February 6, 1984

Docket No. 50-423  
B11026

Millstone Nuclear Power Station, Unit No. 3  
Probabilistic Safety Study (PSS)

2-INCH COLD LEG BREAK PLOTS

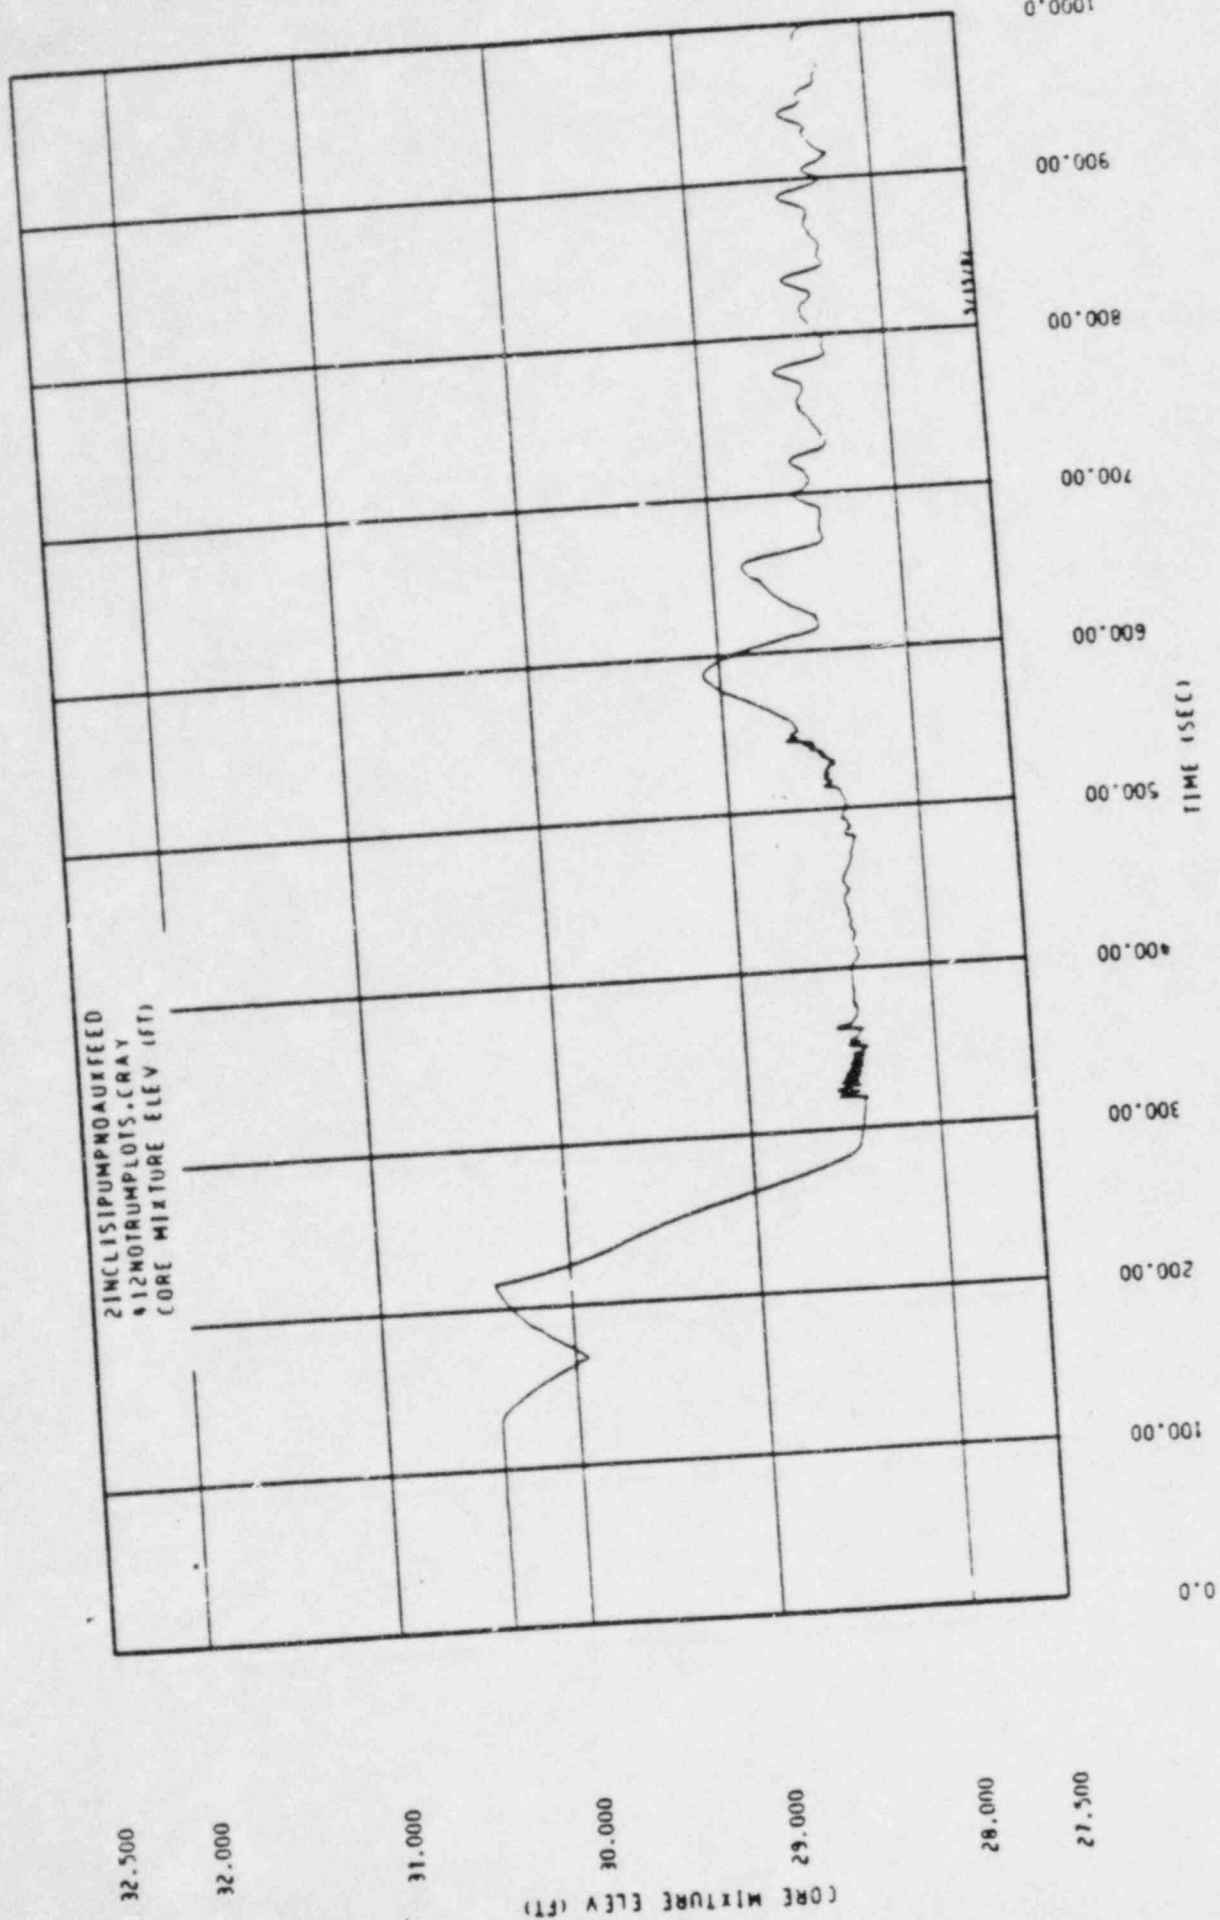
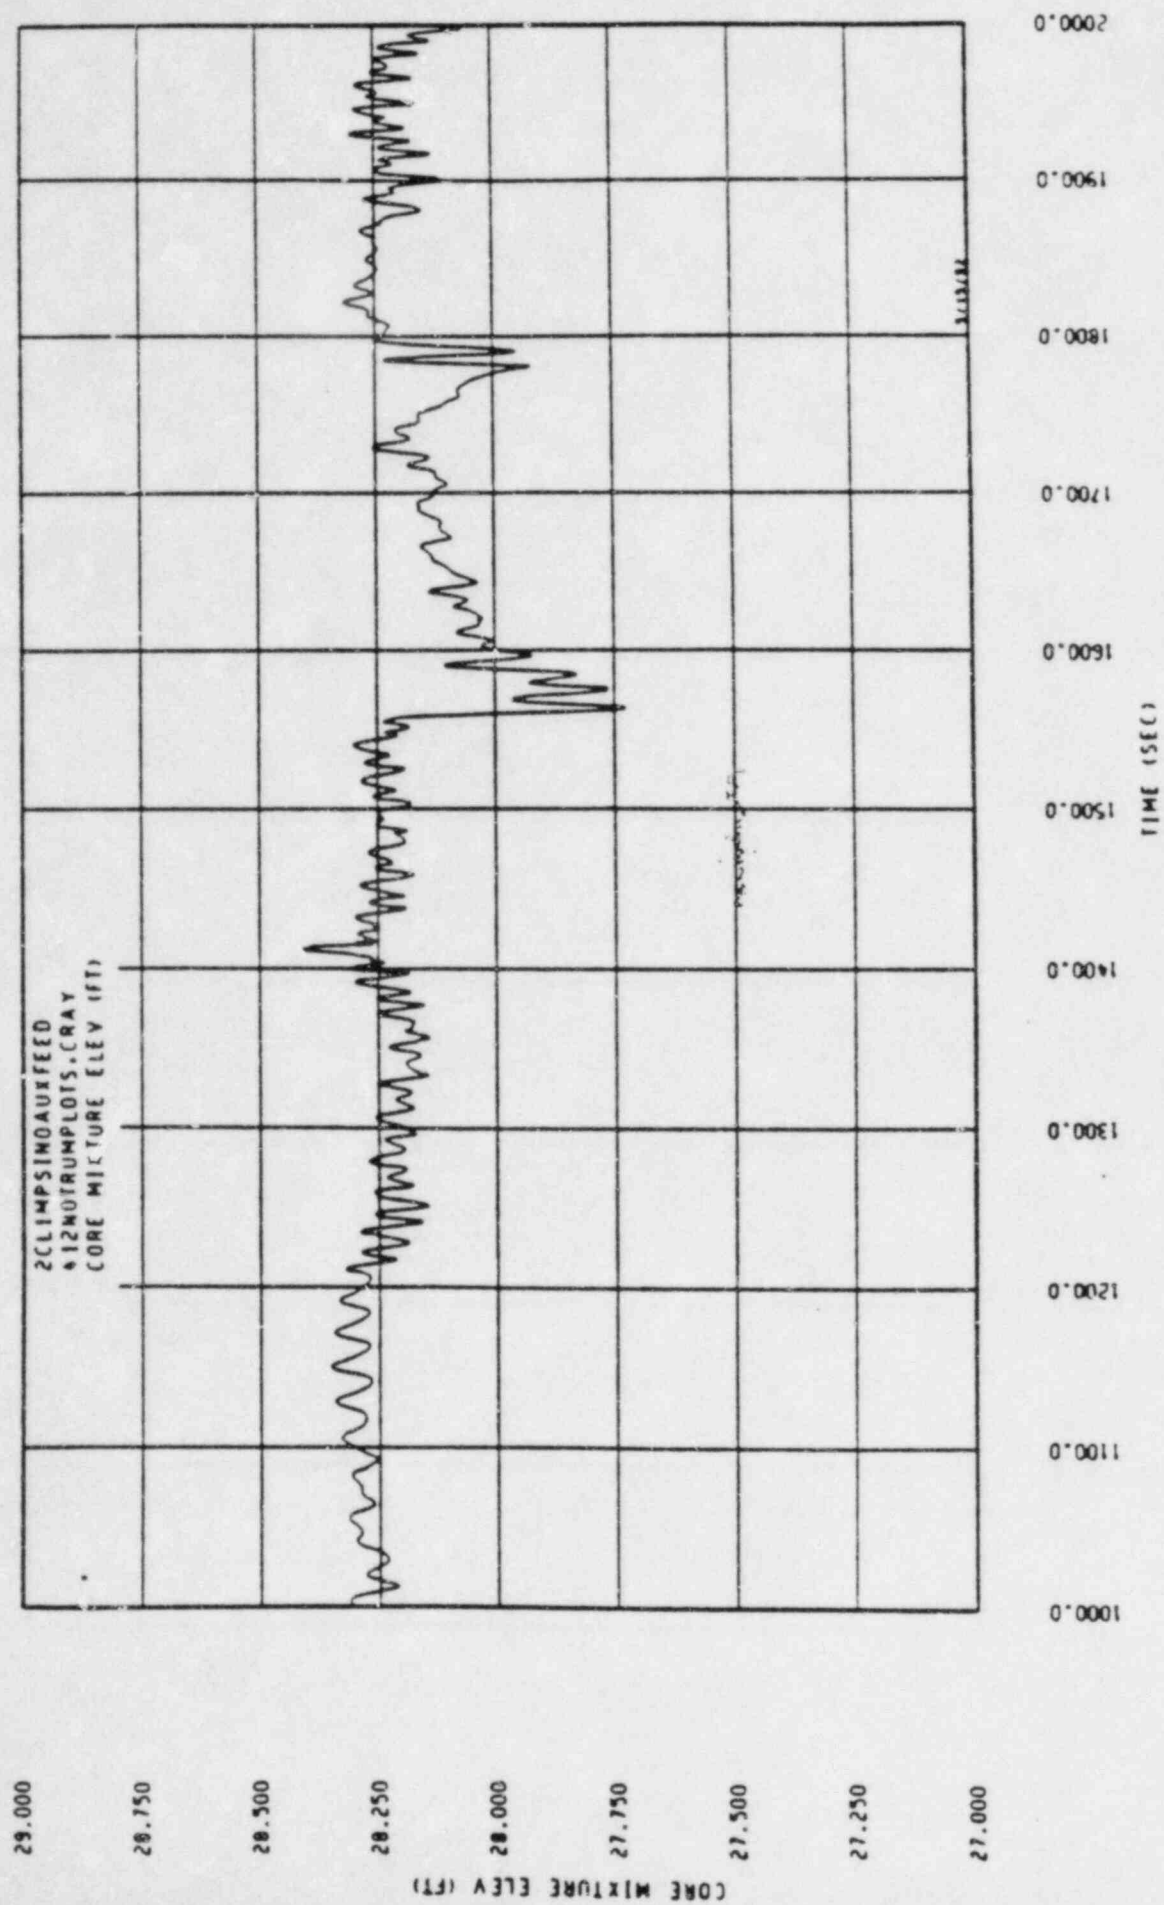
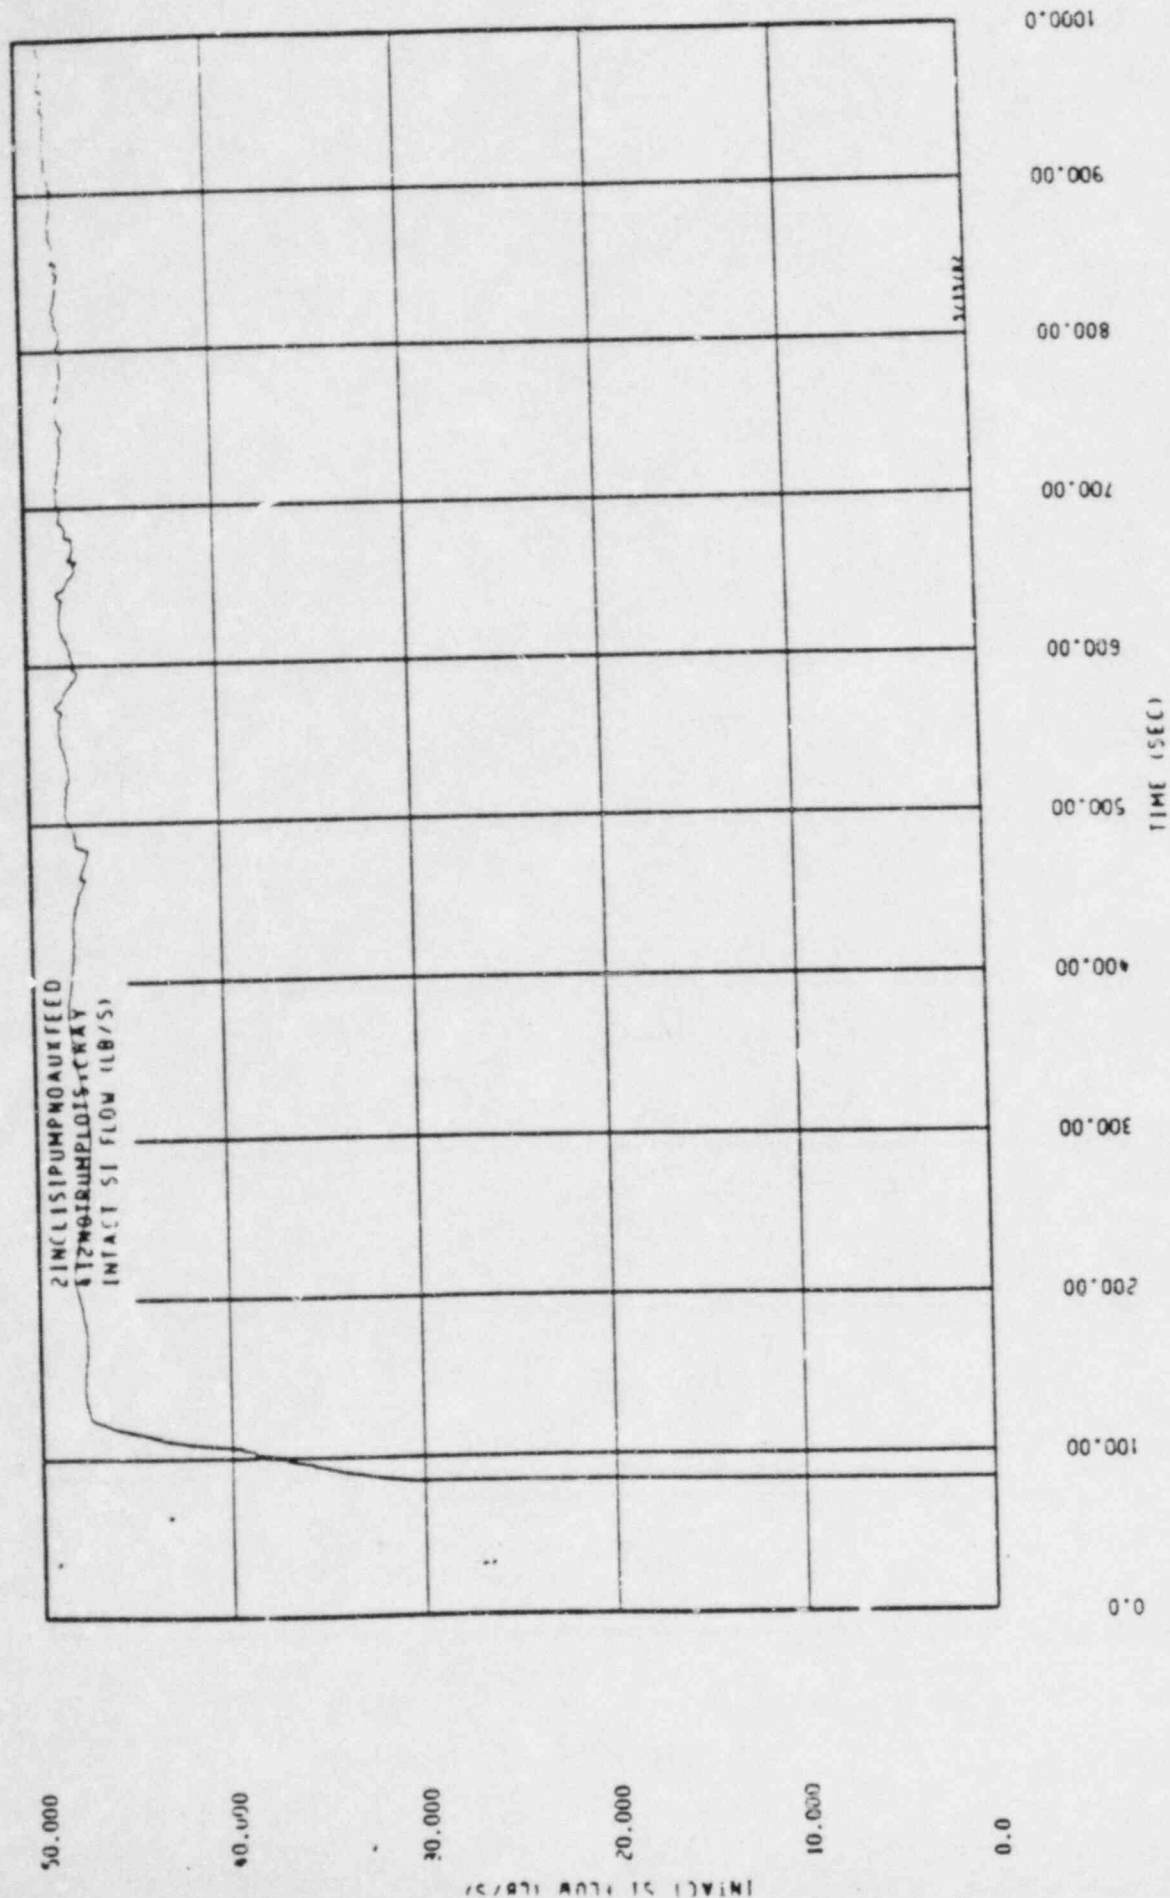
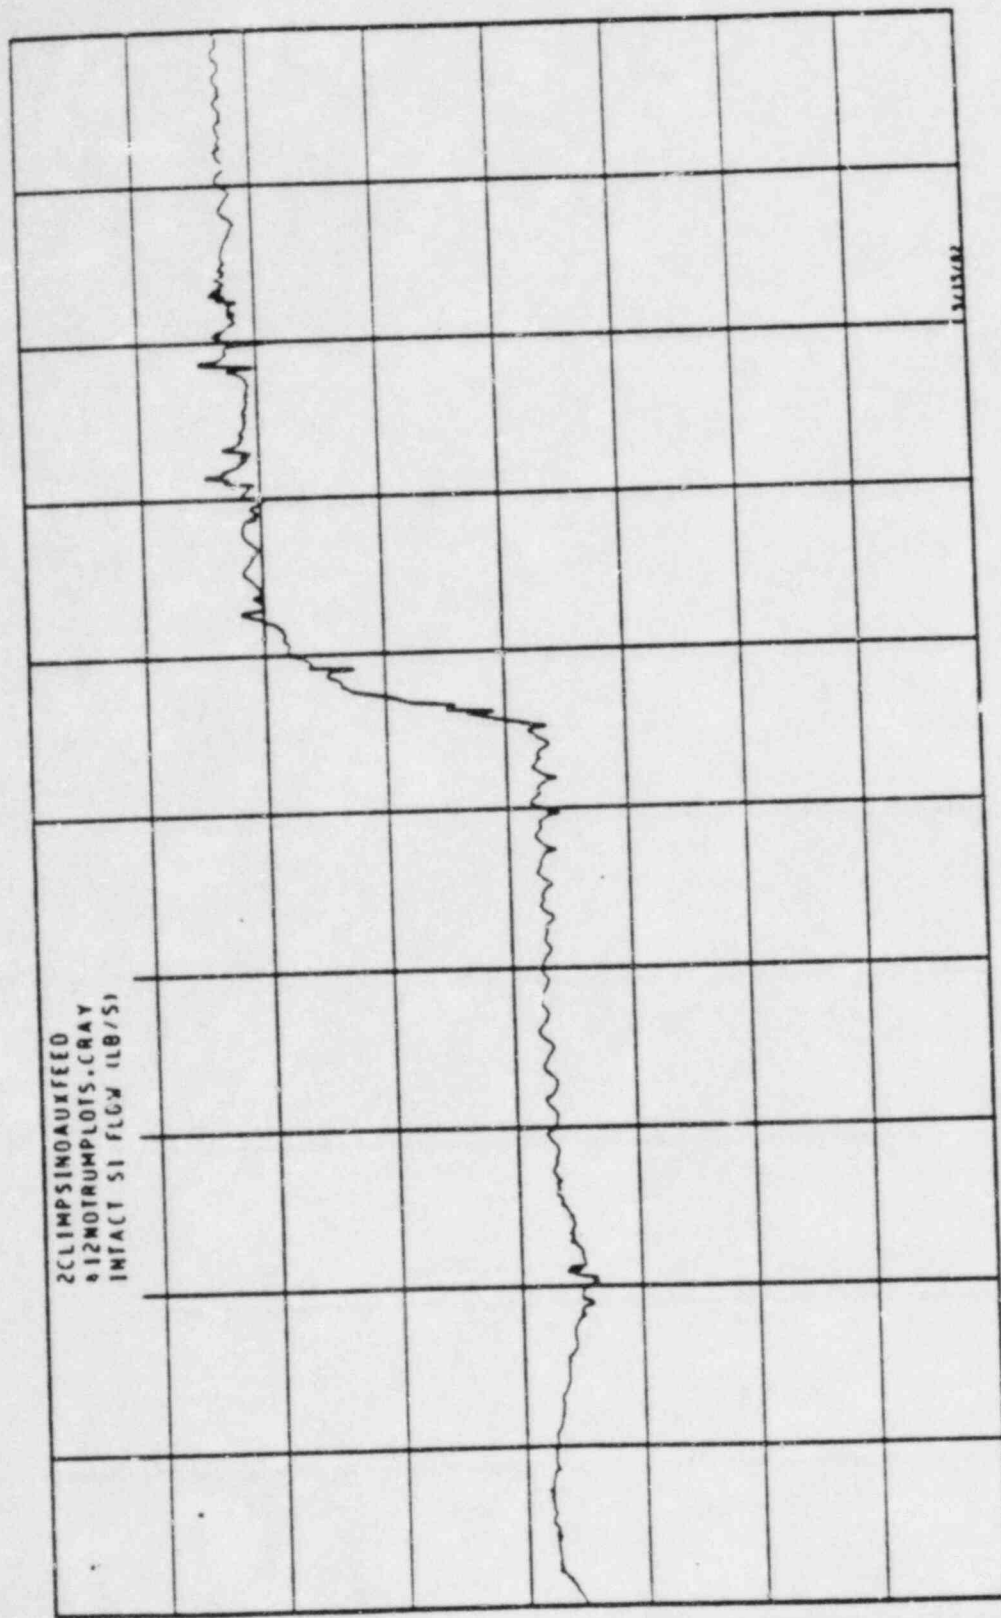
Question 720.3: Provide a summary of Westinghouse Calc Note CN-PRA-83-022 which identifies computer codes used, key assumptions and transient plots used in the analysis.

Response: Westinghouse Calc Note CN-PRA-83-022 provides the necessary calculations to assess the reactor coolant system response to postulated small and medium break loss of coolant accidents for which only minimum safety injection capability is available. The results of these analyses were utilized along with other similar analyses to determine system success criteria for the Millstone Unit 3 PRA.<sup>(1)</sup> This calc note analyzed breaks of 2- and 6-inch diameters. For both breaks, the location was assumed to occur at the RCS cold leg which is the limiting break location for Westinghouse PWRs.<sup>(1)</sup>

The NOTRUMP<sup>(2)</sup> computer code was used to perform the necessary calculations. NOTRUMP is a generalized one-dimensional network code which is used to model operational and severe transients for Westinghouse PWRs. An input model was developed for Millstone Unit 3 and a steady state full power simulation was established and referenced. The two LOCA events analyzed were: Case A models a 2-inch diameter cold leg break from full power conditions and Case B models a 6-inch diameter cold leg break from full power conditions. In both of these cases, it was assumed that no feedwater (normal or auxiliary) was available. This assumption has minimal impact on system response. The minimum safety injection flow to the RCS for both cases was approximately 75% of the capacity of one Millstone Unit 3 high head safety injection pump. This flow rate was chosen to bound the success criteria for Millstone which uses a combination of high head safety injection and charging pumps to accomplish high pressure injection. One charging pump provides approximately 75% of the flow of one SI pump in the pressure range of 0-1200 psig.

Case A calculations were carried out to 2000 seconds of transient time. While this particular calculation was not carried out to a time when the system is in a long term stable condition, the calculation was taken out far enough to show that the trend of the transient would not result in core damage/melt.

These two analyses show that while the flow minimum safety injection flow cannot maintain the RCS inventory above the break location, the flow is sufficient to maintain the vessel mixture level core the core. These conclusions were consistent with conclusions reached for similar LOCA analyses.<sup>(1)</sup> A detailed description of small break LOCA phenomena can be found in WCAP 9600. The transient time plots for key plant parameters for both cases are provided herein.
